Product Change Notification / ALAN-19CNAD783

CCB 6332.001 Final Notice: Qualification of MTAI as the new test location for selected ATTINY85xx, ATTINY45xx, and ATTINY25xx device families available in 8L SOIJ (.208in) and 8L SOIC (.150in) packages.

CCB 6332.001
Pre and Post Change Summary
PCN #: ALAN-19CNAD783

Carrier Tape – T/R- 8L SOIC Package

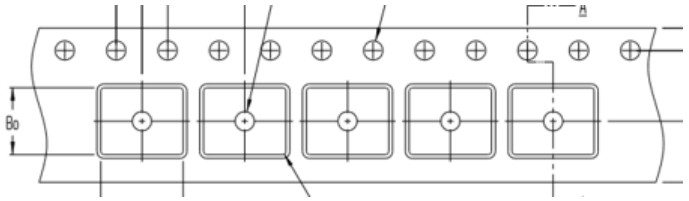
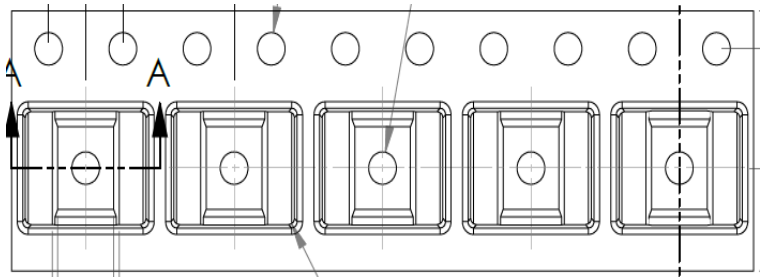
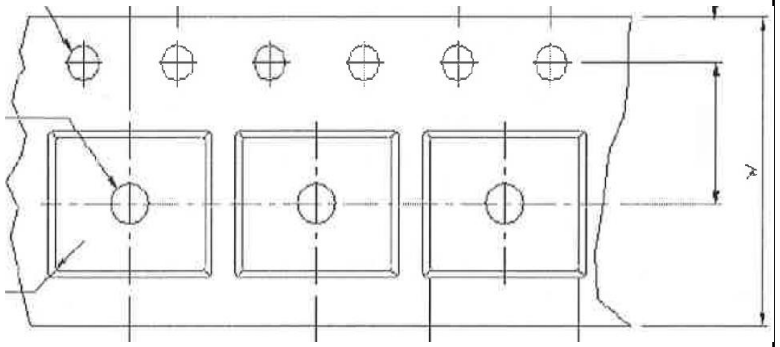
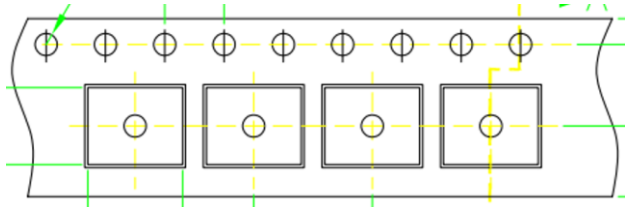
Plant	W (mm.)	P (mm.)	A0 (mm.)	B0 (mm.)	K0 (mm.)
ANAP	12.00 +/- 0.3	8.00 +/- 0.1	6.40 +/- 0.1	5.20 +/- 0.1	2.10 +/- 0.1
LPI	12.00 +0.3/-0.1	8.00	6.50 +/- 0.1	5.20 +/- 0.1	2.10 +/- 0.1
MTAI	12.00 +/- 0.3	8.00 +/- 0.1	6.40 +/- 0.1	5.20 +/- 0.1	2.10 +/- 0.1

Reel – T/R - 8L SOIC Package

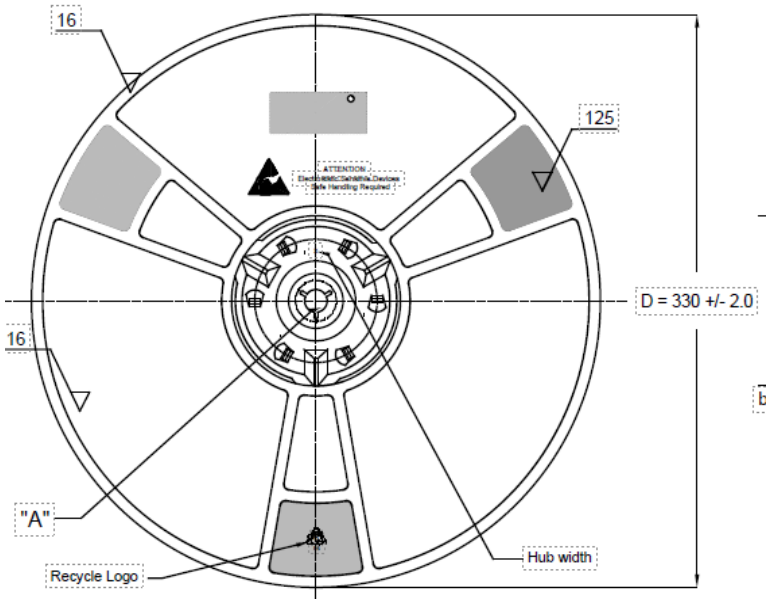
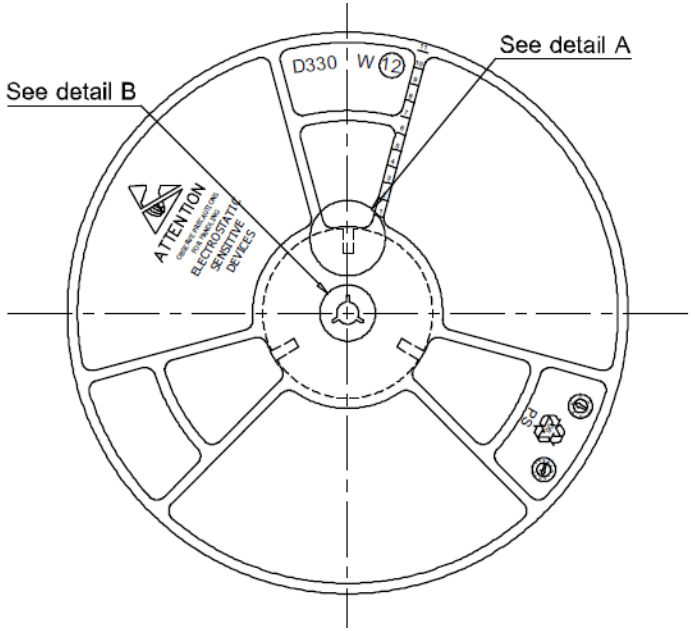
Plant	Colour	Diameter	Hub Dia	W1	W2
ANAP	**White**	**329.99mm**	**100mm**	**13.5mm**	**17.5mm**
LPI	**White**	**330mm**	**102mm**	**4.4mm** **8.4mm**	**7.1mm** **11.1mm**
MTAI	**Dark Blue**	**330mm**	**100mm**	**12.40mm**	**18.40mm**

Cover Tape – T/R - 8L SOIC Package

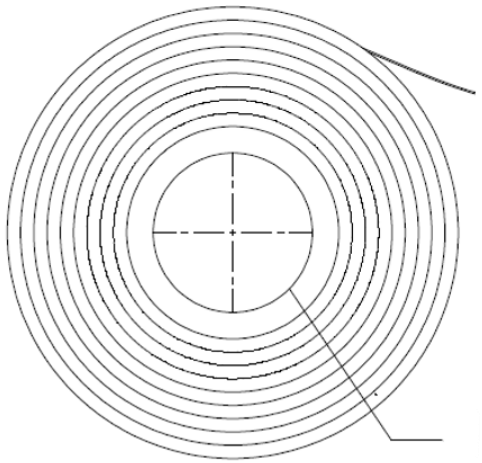
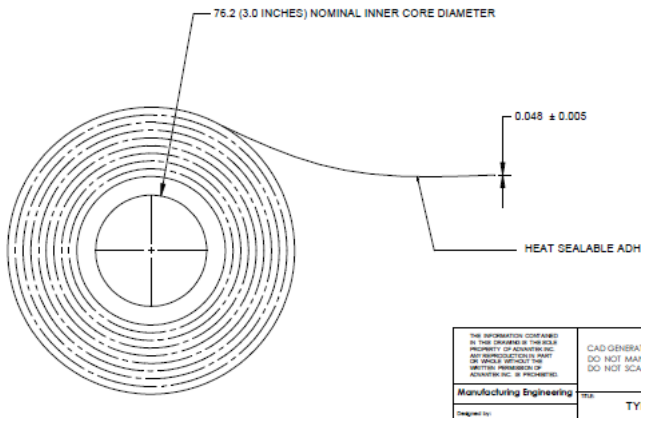
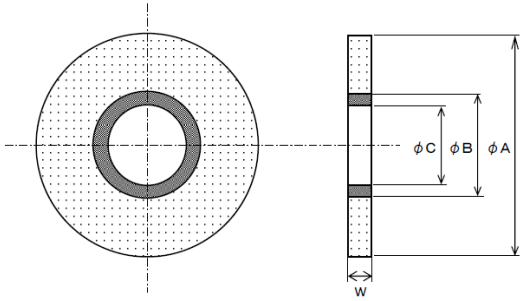
Width	9.2 mm
Thickness	0.053mm

Width	9.2mm
Thickness	0.048mm

Width	9.05mm
Thickness	0.050mm

Tube - 8L SOIC Package

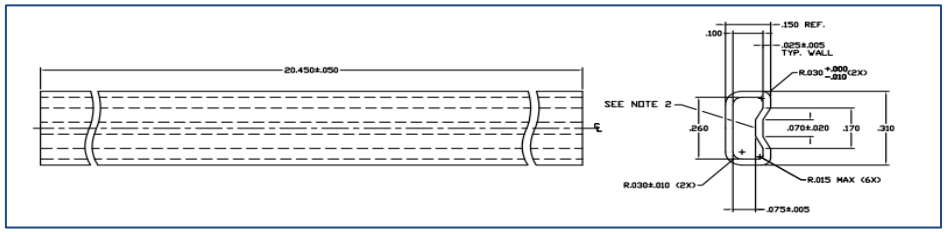
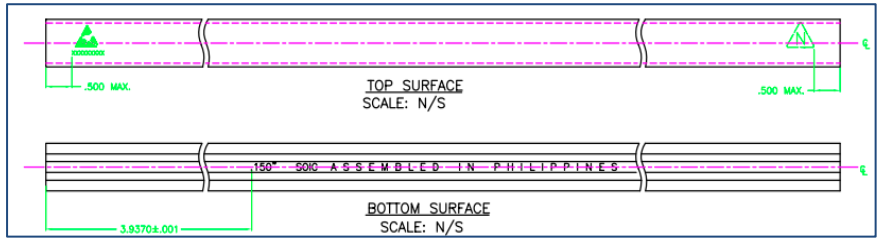
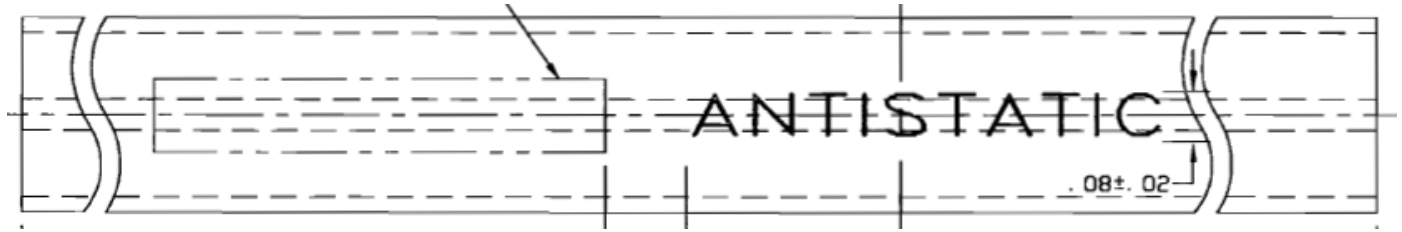
Length	20.45 in
Color	Clear Blue

Length	20.4 in
Color	Clear

Length	20.5 in
Color	Clear

Carrier Tape – T/R - 8L SOIJ Package

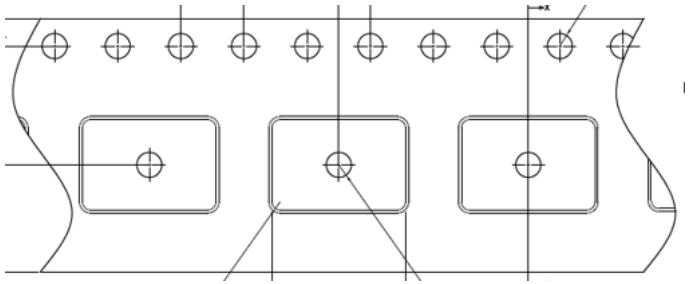
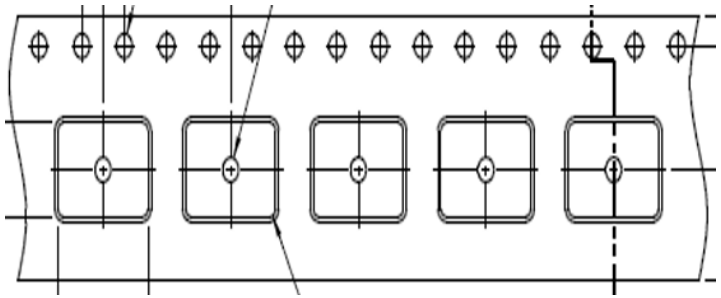
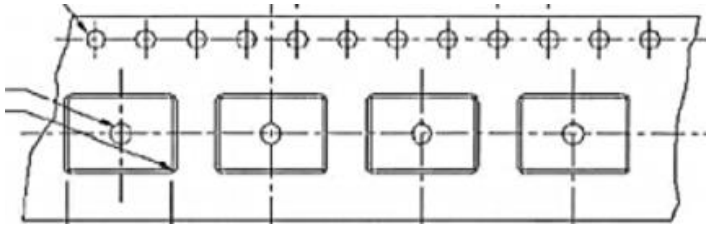
Plant	W (mm.)	P (mm.)	A0 (mm.)	B0 (mm.)	K0 (mm.)
ANAP	16.00 +0.3/-0.1	12.00 +/- 0.1	8.45 +/- 0.1	5.70 +/- 0.1	2.35 +/- 0.1
LPI	16.00	12.00	8.450 +/- 0.1	5.70 +/- 0.1	2.35 +/- 0.1
MTAI	16.00	12.00	8.30 +/- 0.1	5.70 +/- 0.1	2.30 +/- 0.1

Reel – T/R - 8L SOIJ Package

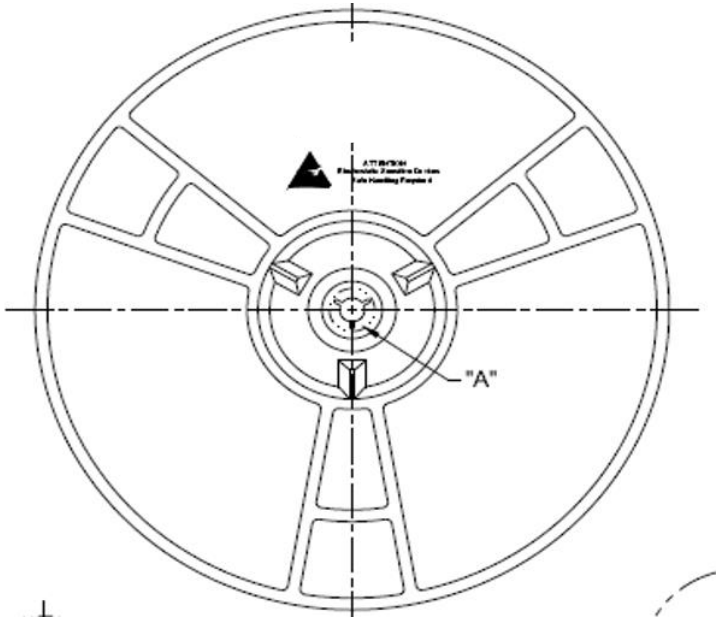
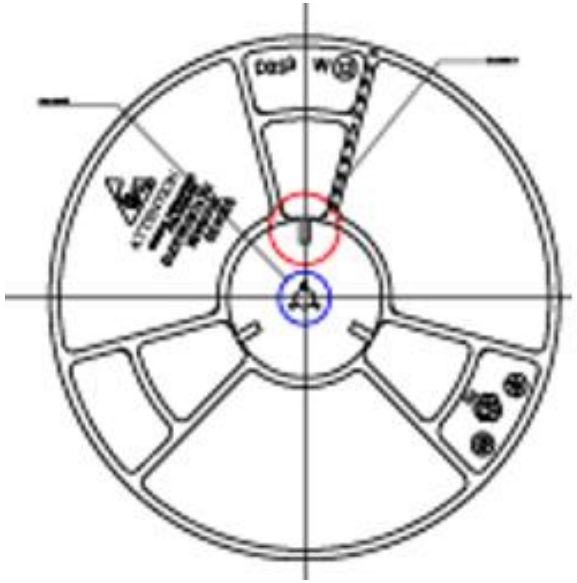
Plant	Colour	Diameter	W1	W2
ANAP	White	329.99mm	17mm	19.4mm
LPI	White	330mm	4.4mm 8.4mm	7.1mm 11.1mm
MTAI	Dark Blue	330mm	16.40mm	22.40mm

Cover Tape – T/R - 8L SOIJ Package

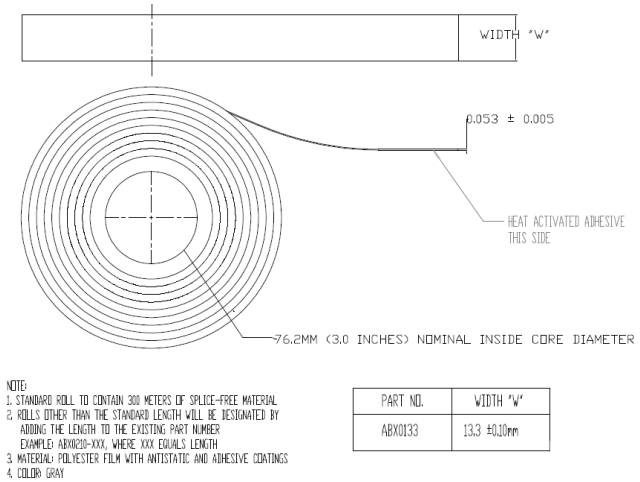
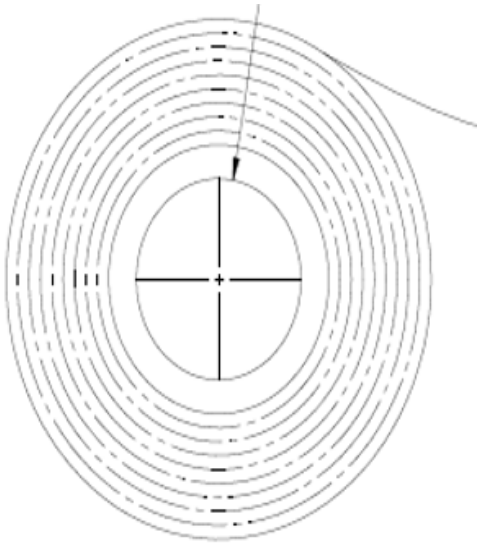
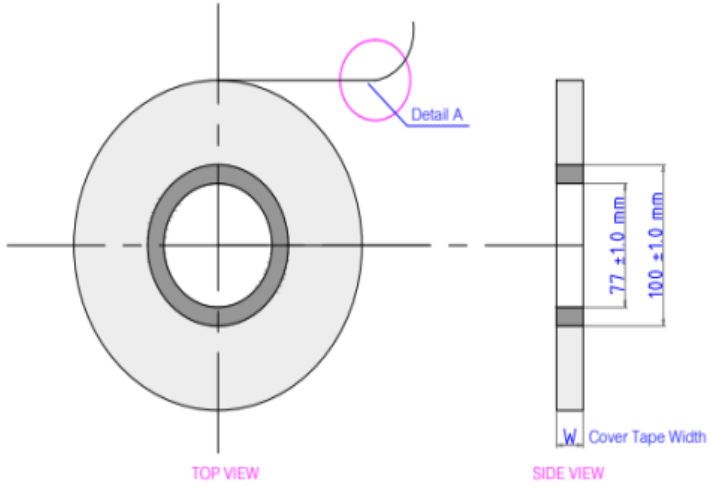
Width	13.33 mm
Thickness	0.053mm

Width	13.3 mm
Thickness	0.048mm

Width	13.3 mm
Thickness	0.050mm

Pin Orientation - Tube - 8L SOIJ Package

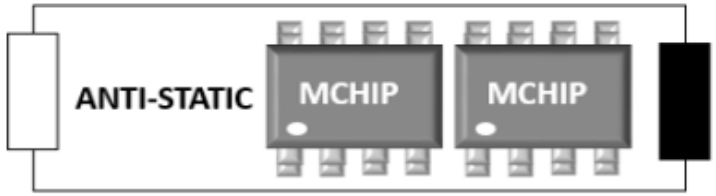
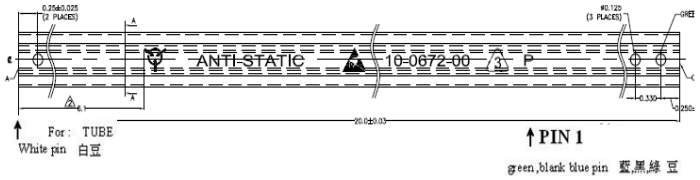
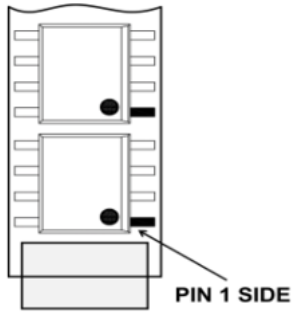
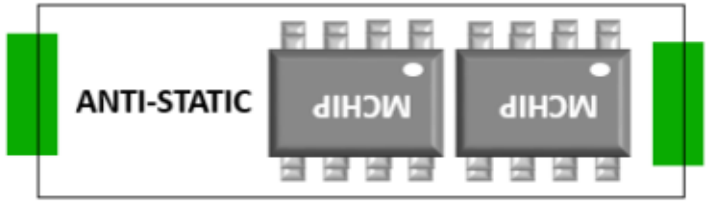
ANAP	LPI	MTAI
MSL 1 LOWER LEFT REFERENCE TO TUBE MARKING

**PLUG** **Pin 1 Side:** WHITE **Opposite Side:** BLACK

MSL 2 UPPER RIGHT REFERENCE TO TUBE MARKING

Tube - 8L SOIJ Package

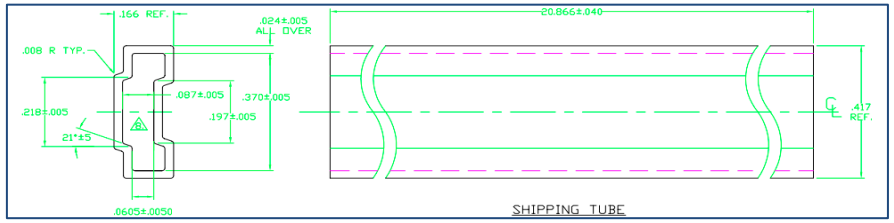
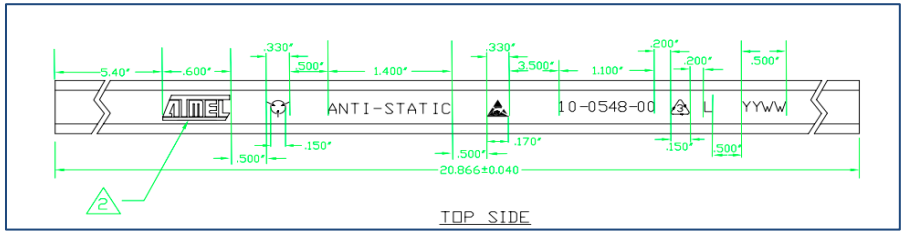
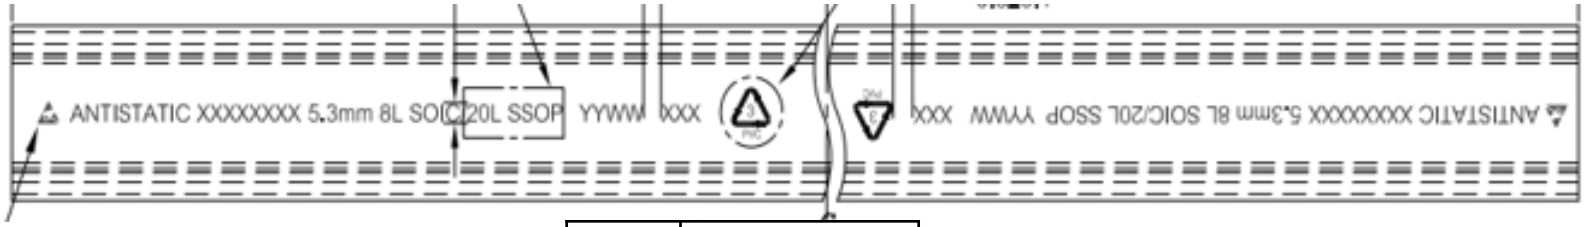
Length	20.866 in
Color	Clear Blue

Length	20.86 in
Color	Clear

Length	20 in
Color	Clear
